ARCHITECTURAL BARRIER-FREE
DESIGN COMMITTEE

August 19, 2004

Thank you for your swift response to my letter dated July 13, 2004. I was disappointed that you were not able to meet with me on July 27 but I did meet with Gary Boisvert, Code Enforcement Official for the town of Belmont. Together we did an accessibility evaluation of the Town Hall.

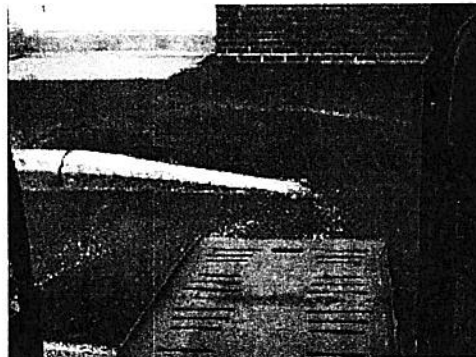
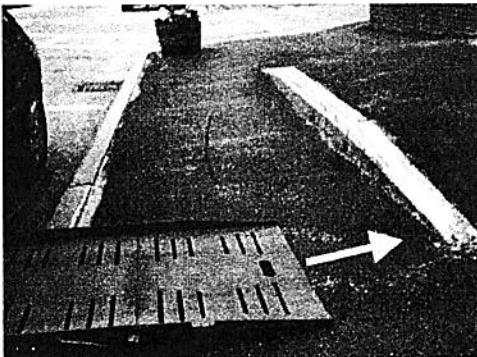
There should be at least one van-accessible parking space (a 96 inch wide space with an adjacent 96 inch wide access aisle). The existing on-street parallel *accessible* parking space is not compliant per ADAAG 4.6. An on-street parallel parking configuration cannot provide the required access aisle (ADAAG 4.6.3). The sidewalk has within it an additional curbing and a second level of sidewalk which, for a van with a lift or ramp that deploys on the passenger side of the vehicle, results in insufficient maneuvering space (a minimum of 96 inches in width). For other vehicles, either the driver would be forced to maneuver a wheelchair within the path of traffic or the passenger would have to maneuver the wheelchair next to the vehicle, several inches above the street level, on the sidewalk. Both of these are difficult and dangerous maneuvers.

Gary did state that handrails will be installed along this second level of the sidewalk to prevent falls from one level to the other, however, it remains that the location of this sidewalk interferes with exiting a vehicle.

The curb ramp does not have the required detectable warning per ADAAG 4.7.7.

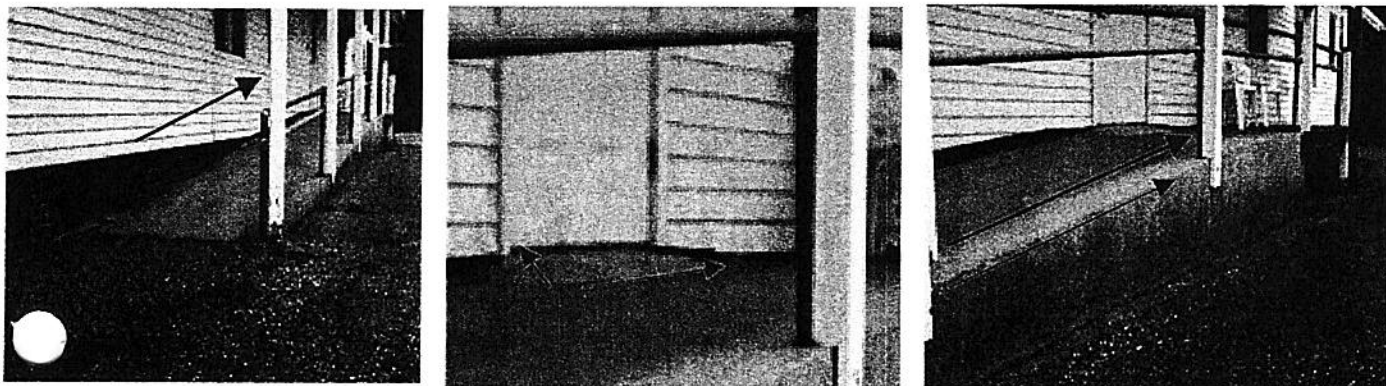
The ramp does not meet the requirements of section 4.8 of ADAAG. The slope exceeds 1:12 (4.8.2) – the ramp is 32 inches in height and 26 feet 7 inches in length, for a grade of approximately 1:10; the landing at the top does not comply with 4.8.4, there is only one handrail where they should be on both sides of the ramp (4.8.5 (1)), and there is no edge protection along the street side of the ramp (4.8.7).
